FOR PUBLIC HEARING
PETITION NO. 2006-48

Providence Road
West Area Elementary
Charlotte Mecklenburg Schools
Charlotte, NC
Petition Number 2006-48

Schematic Site
Plan

Technical Data
Sheet

RZ. I

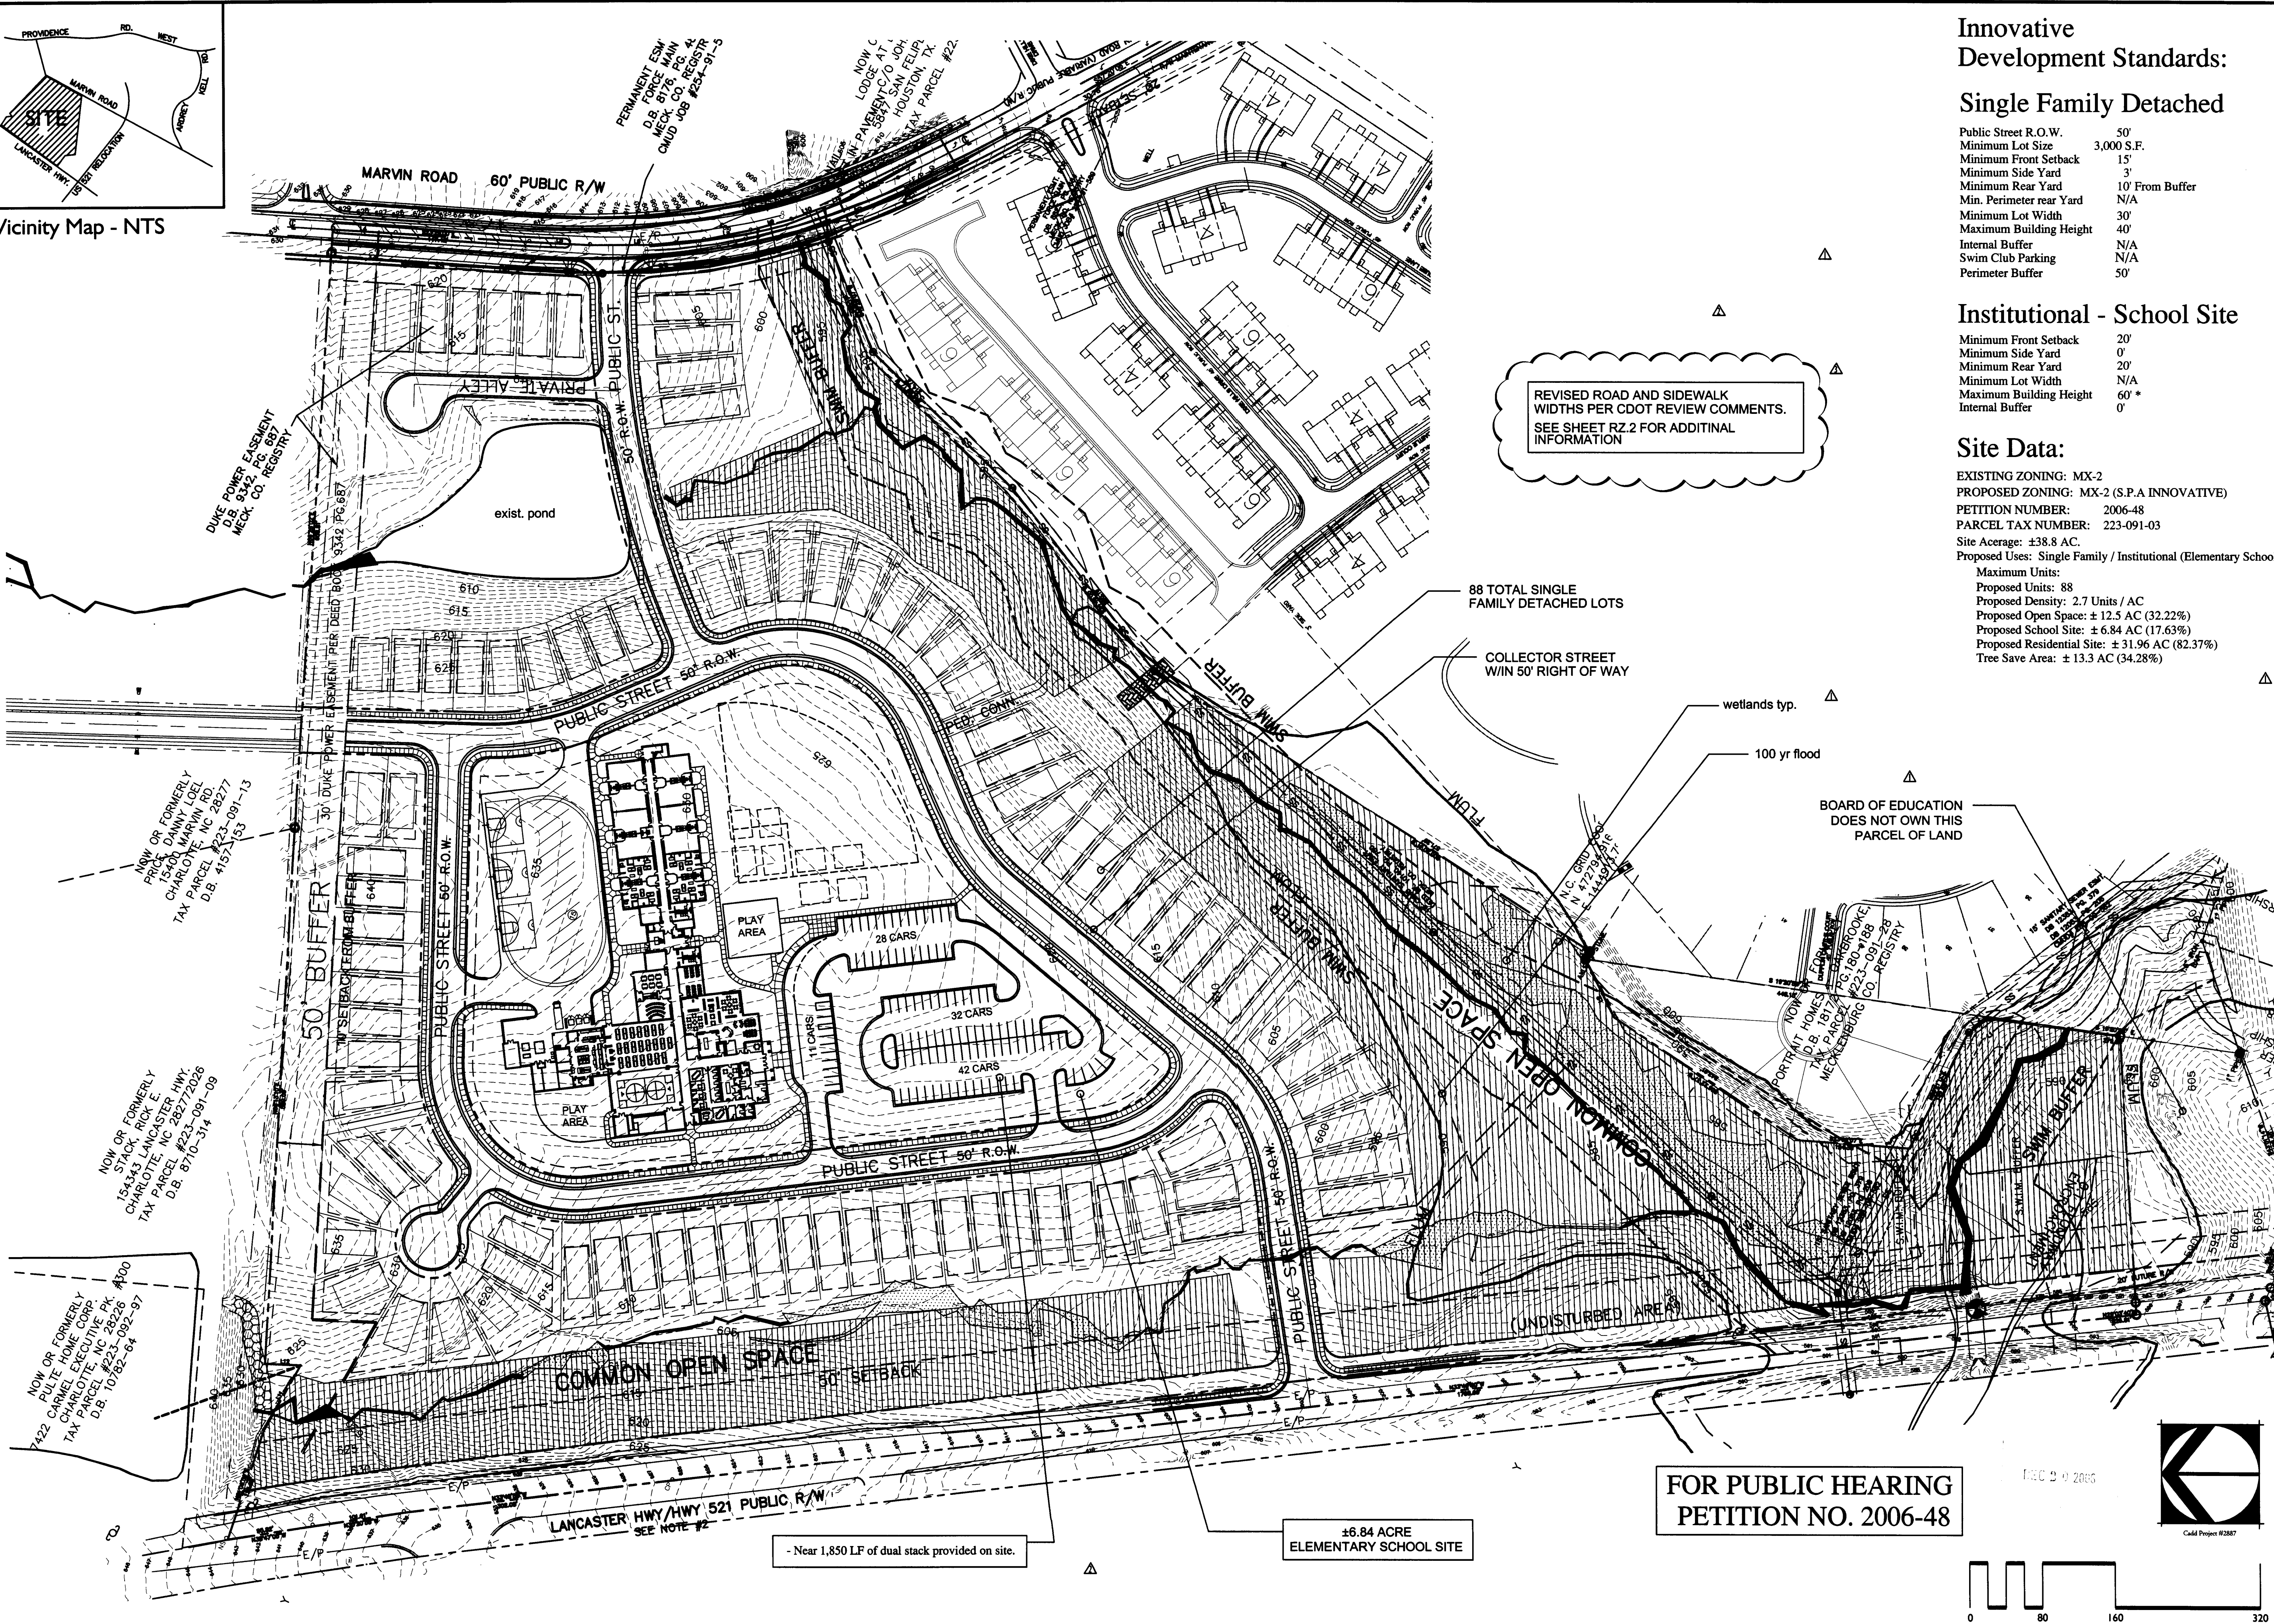
In addition to the notes referenced above, the petitioner has agreed to modify the site plan map and notes in the following manner in order to address comments received from the Charlotte Department of Transportation:

Vertical curb and gutter (2'-6") will be provided on the school side of the ring road. Valley curb (2'-0") will be permitted on the residential side of the ring road.

With respect to the internal road leading from Lancaster Hwy to Marvin Rd, the pavement section along the first 150 feet leading from Lancaster Hwy will be 30' wide. The pavement section along the remainder of the road will be 27' wide, with a parking lane included on the northern side of the road segment adjacent to the school site.

The northern side of the road leading from Lancaster Hwy to Marvin Rd shall be built with a minimum 6' sidewalk.

This information is represented graphically on the plan.
